ADDENDUM FIVE AVONDALE YOUTH AND FAMILY DEVELOPMENT CENTER SITE IMPROVEMENTS CONTRACT NO. Y-15-008-203 CITY OF CHATTANOOGA, TENNESSEE

The following changes shall be made to the Contract Documents, Specifications, and Drawings:

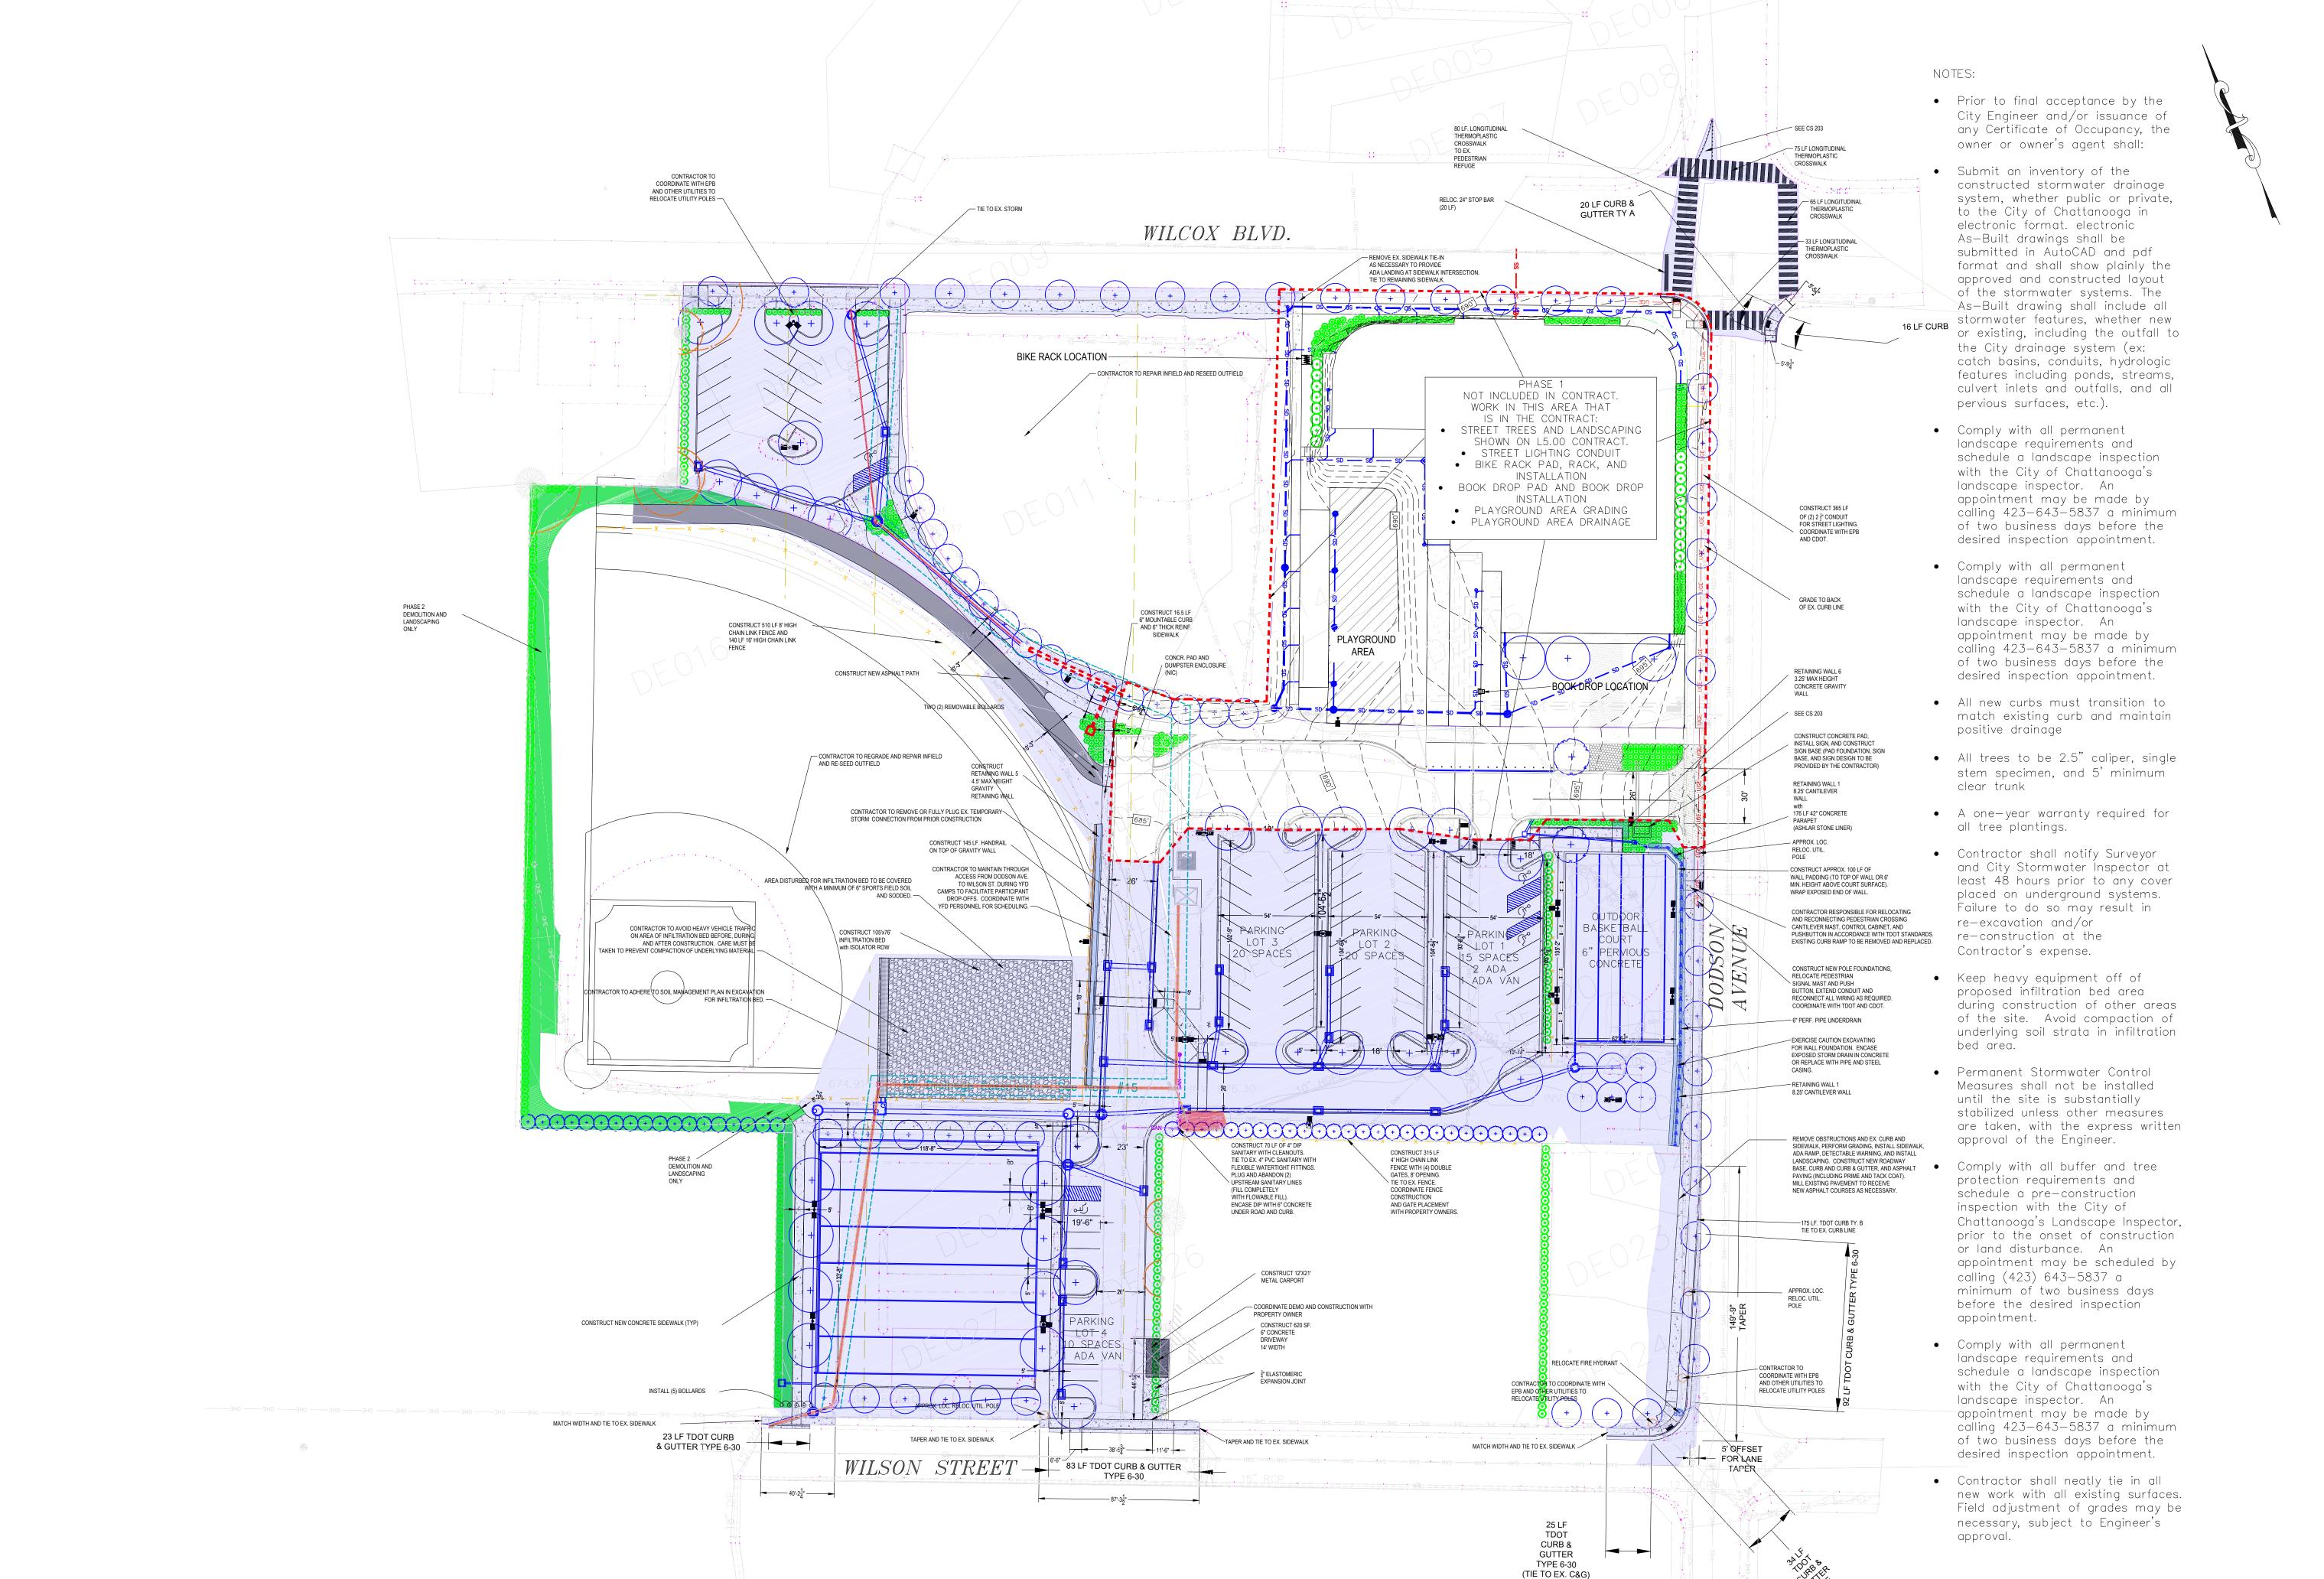
- I. Revised Plans
 - A. Revised drawings CS 030, CS 050.
 - B. Added drawing GI 101.
- II. Q&A
- Q: Addendum #2 Section 116623 references Wall Safety Pads. Are we to furnish this item and if so what is the quantity?

- **A:** Wall Safety Pads are to be provided. 100' LF of outdoor pads are required, 6' minimum height. Pads are now noted on CS 030.
- Q: Is there to be irrigation for the sports field?

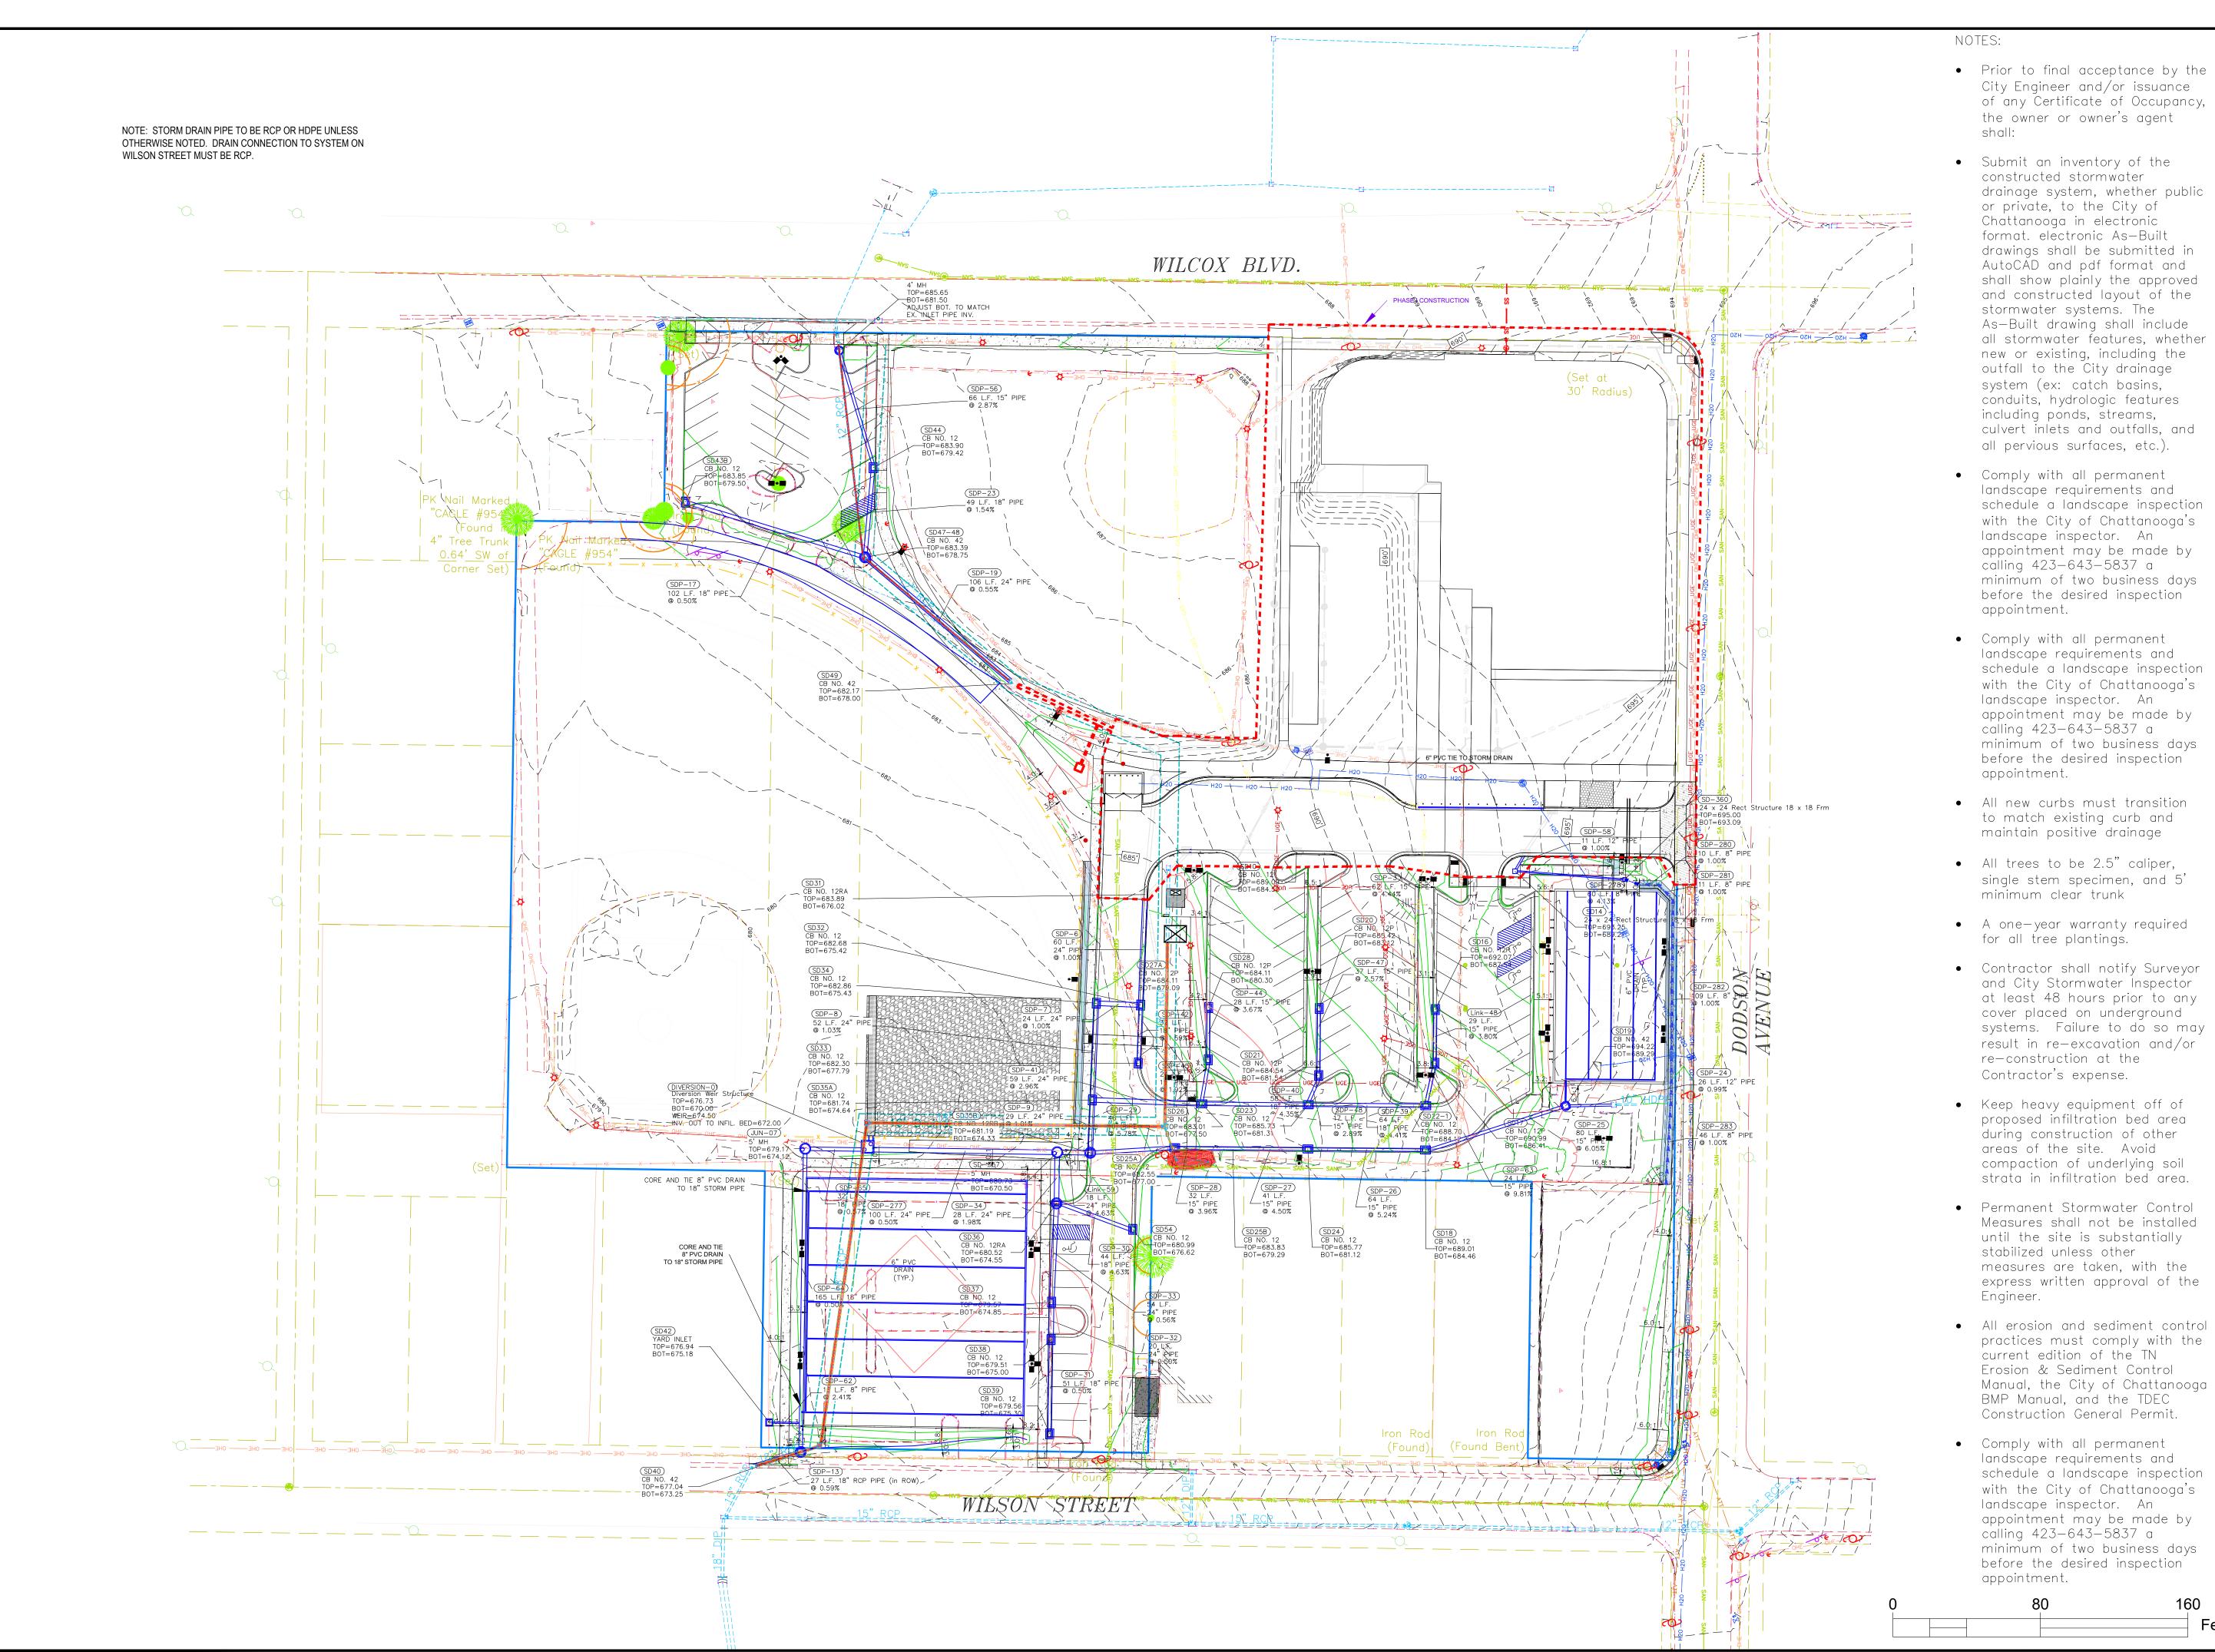
- Q: Please provide a detail and/or a cut section for the infiltration bed.
- A: Sheet GI 101 is included in this Addendum.

- Keep heavy equipment off of proposed infiltration bed area during construction of other areas of the site. Avoid compaction of underlying soil strata in infiltration bed area.
